BALTIMORE COUNTY PUBLIC SCHOOLS

ADDENDUM NUMBER _1_

BID NAME: NEW SCHOOL CONSTRUCTION LANSDOWNE ELEMENTARY
SCHOOL/DEMOLITION OF LANSDOWNE ELEMENTARY
SCHOOL__

BID NUMBER: **MBU-516-17**

ADDENDUM #
1

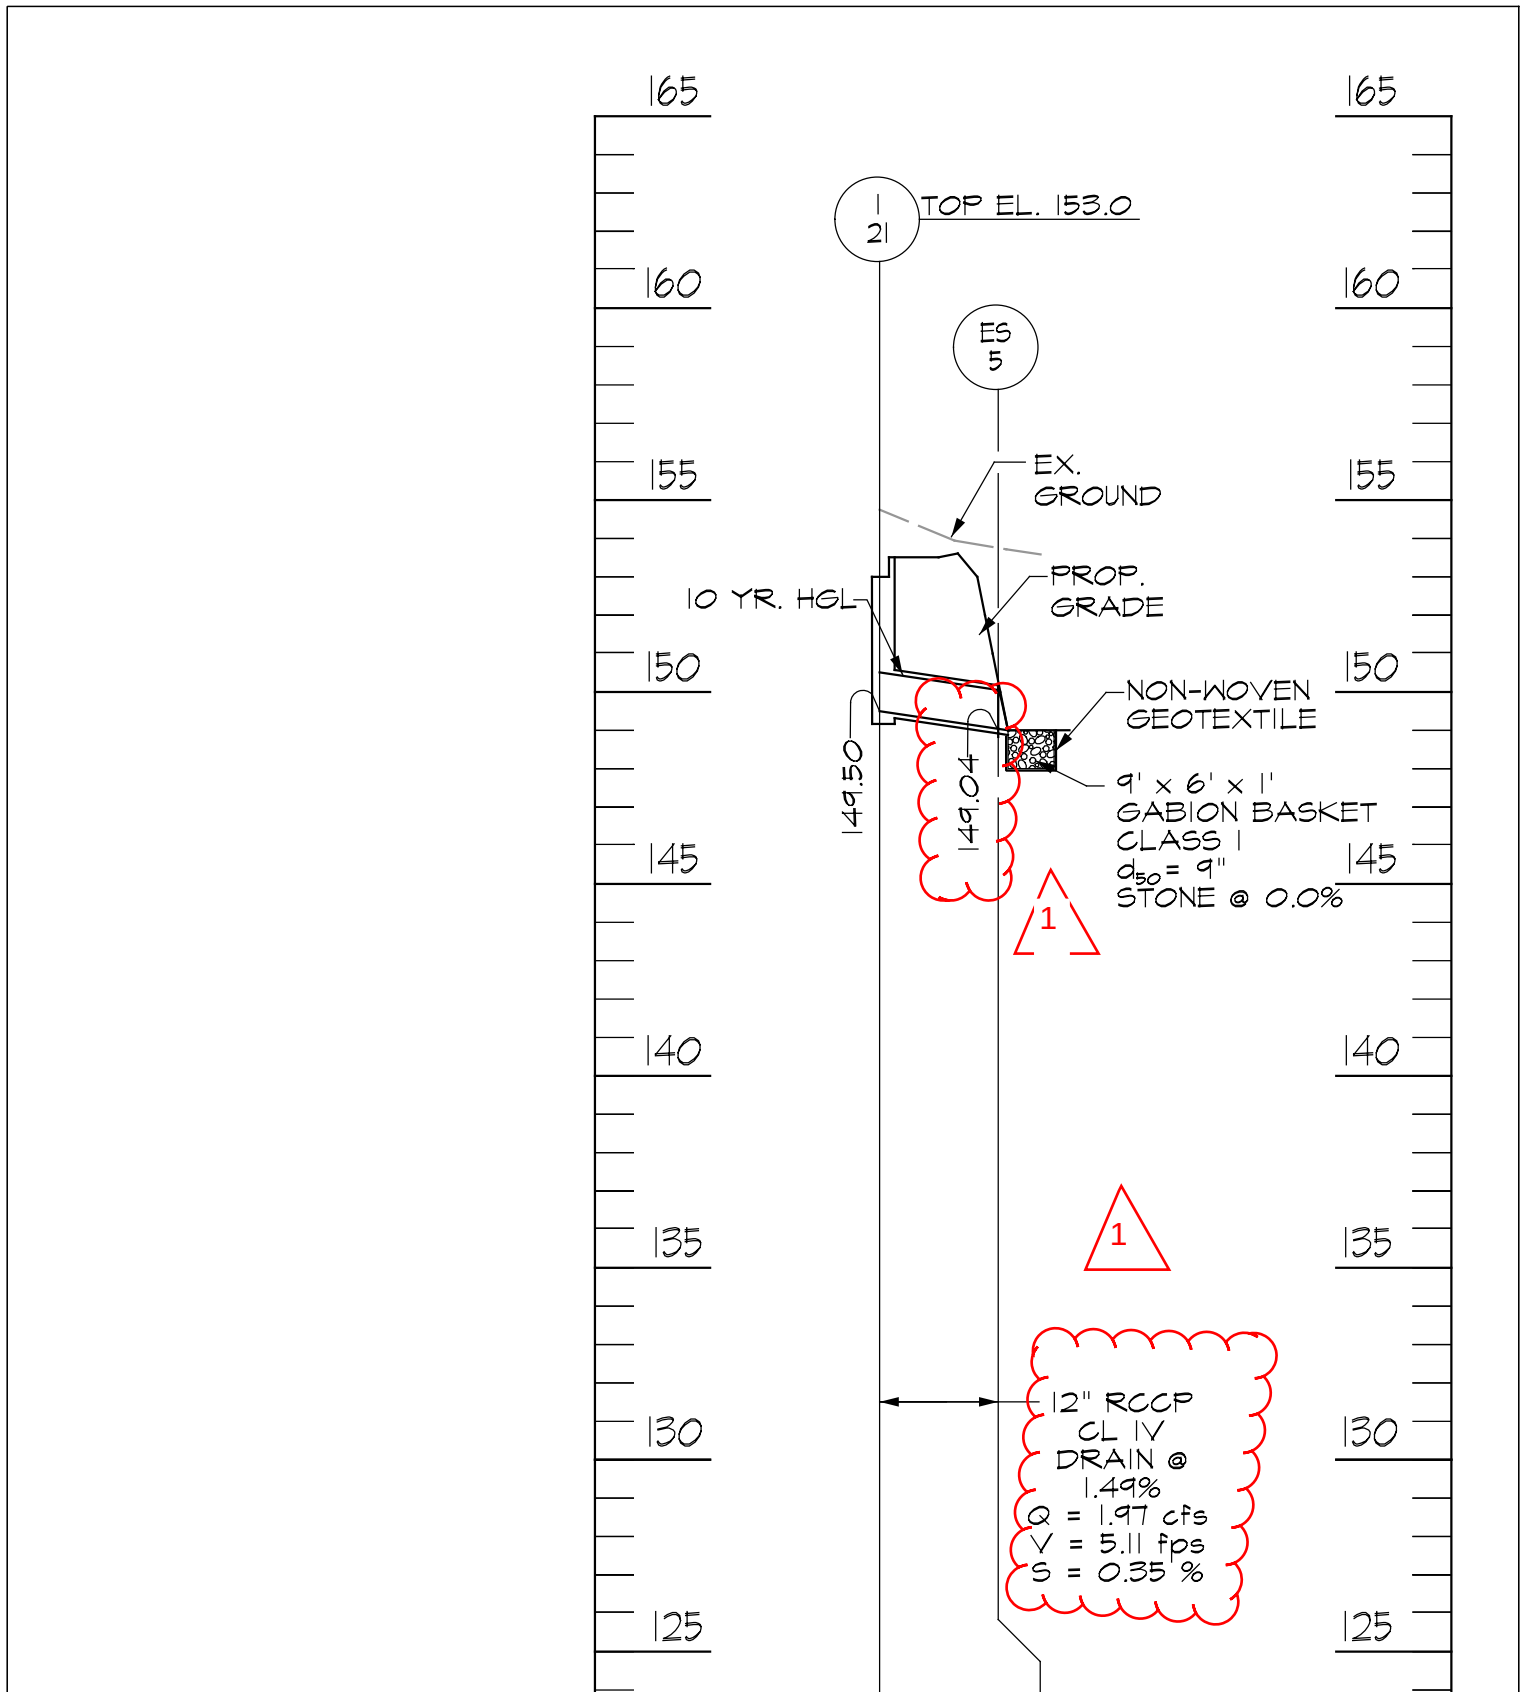
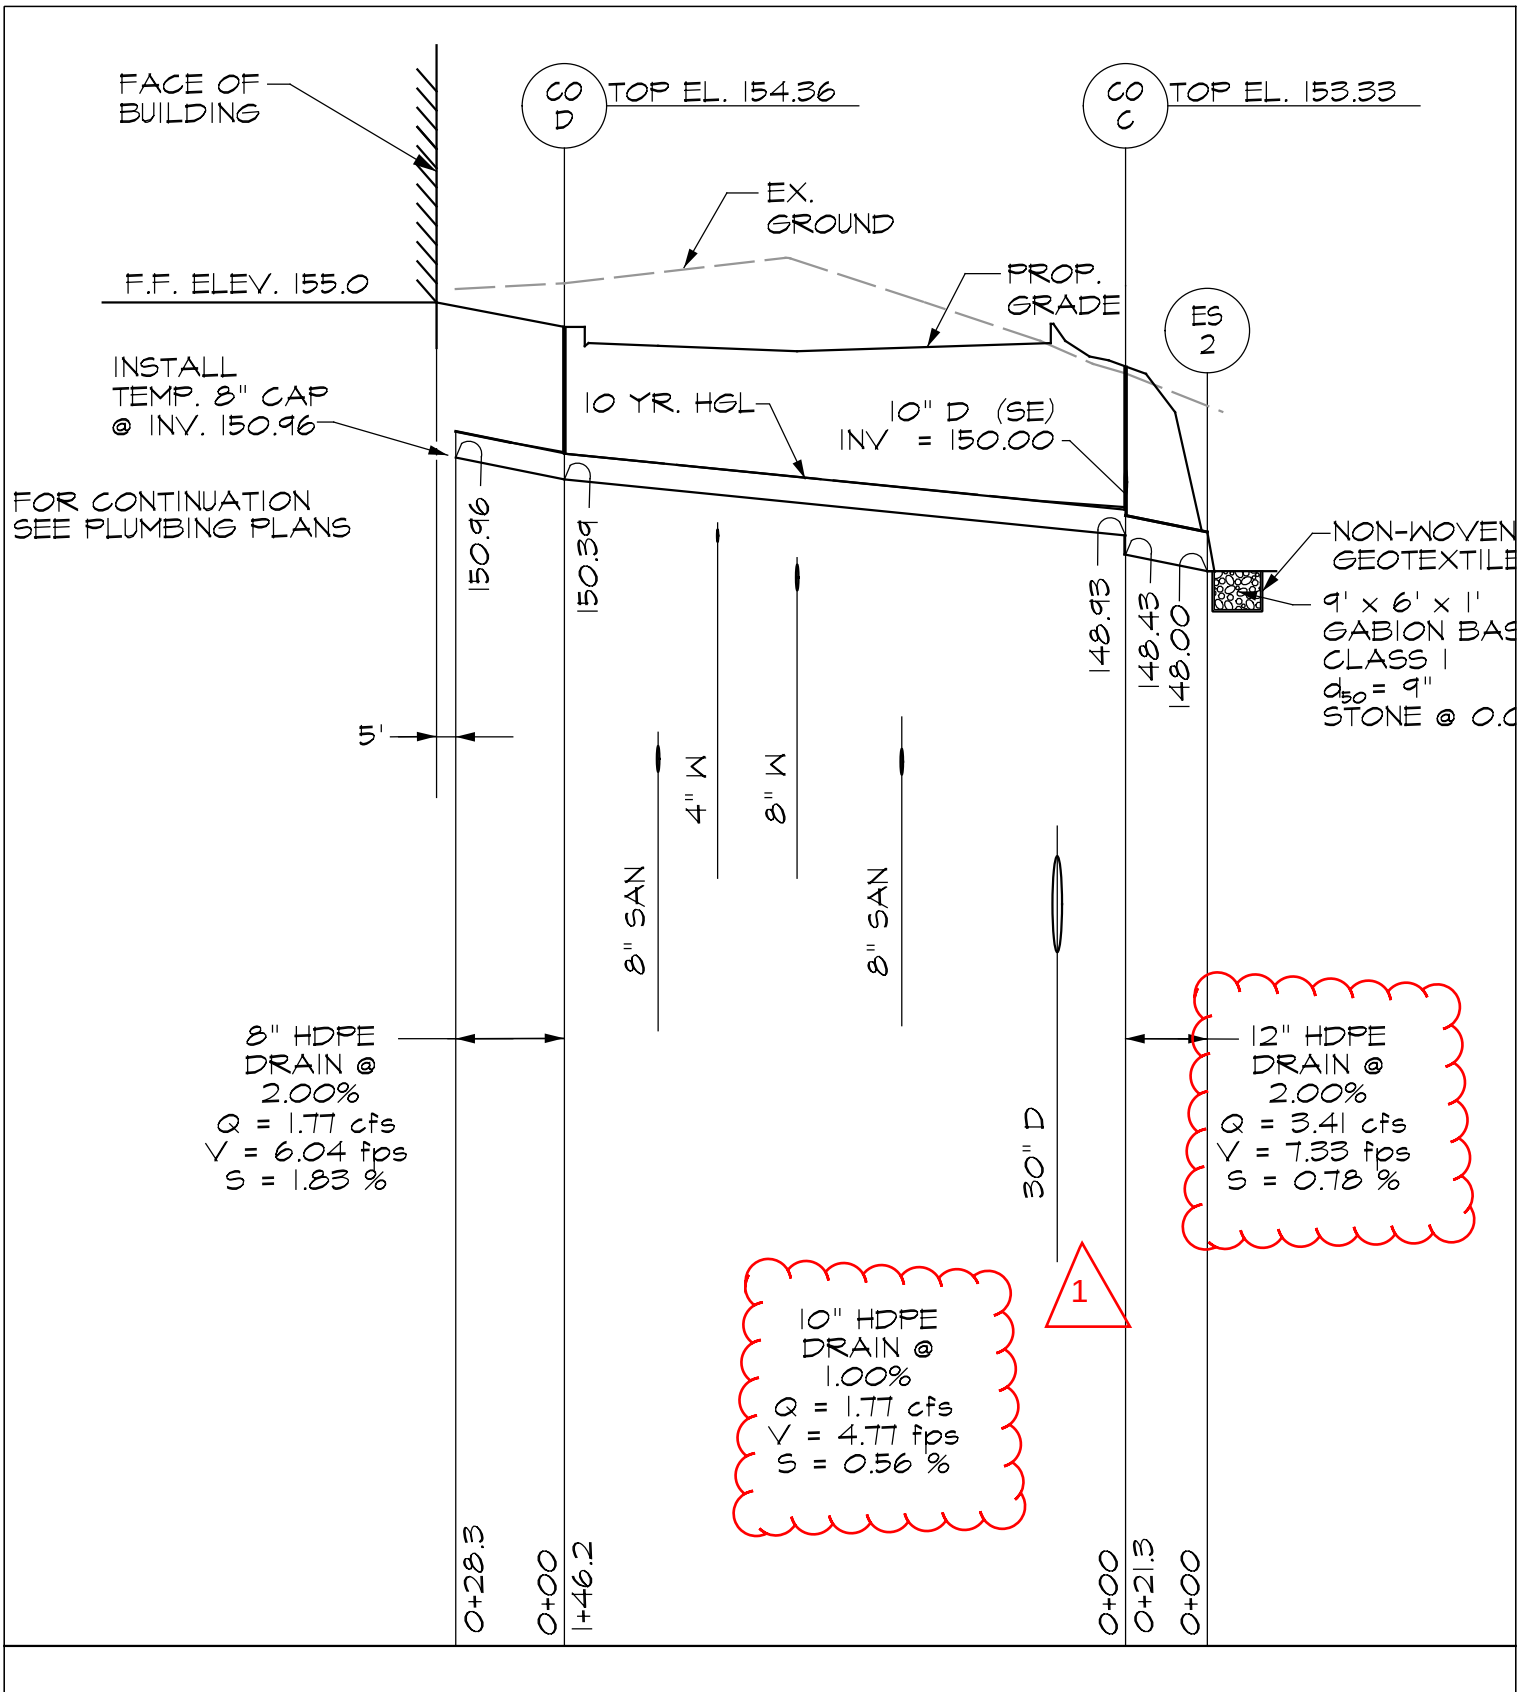
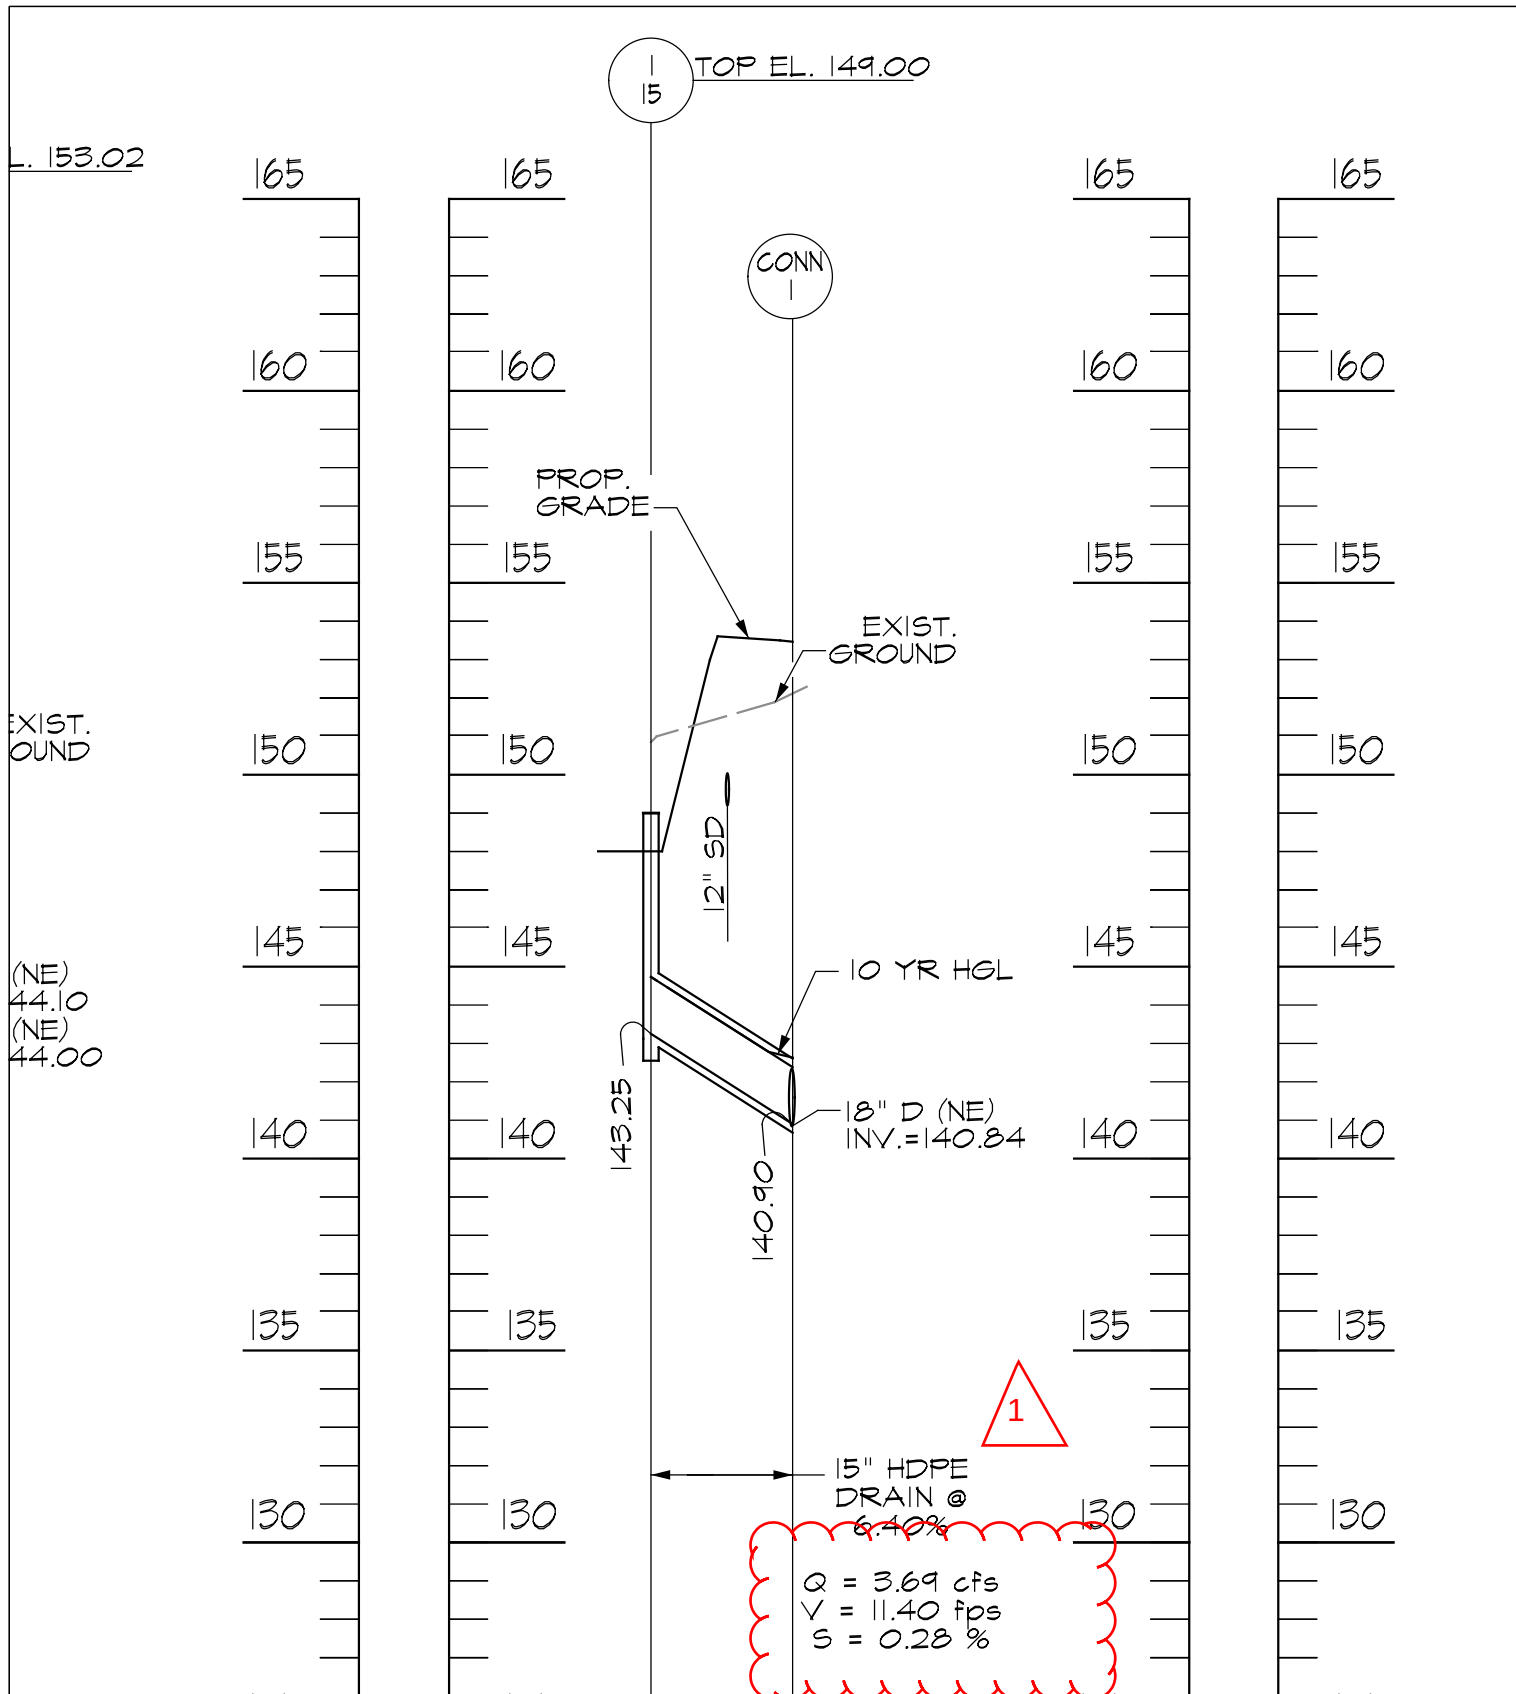
- 3.12. SHEET C-4.4, UTILITY PROFILES
REVISE: Storm Drain Profiles as indicated in attached sketches SK-C-11 – 11G.
- 3.13. SHEET C-4.5, UTILITY PROFILES
REVISE: Storm Drain Profiles as indicated in attached sketch SK-C-12 – 12E.
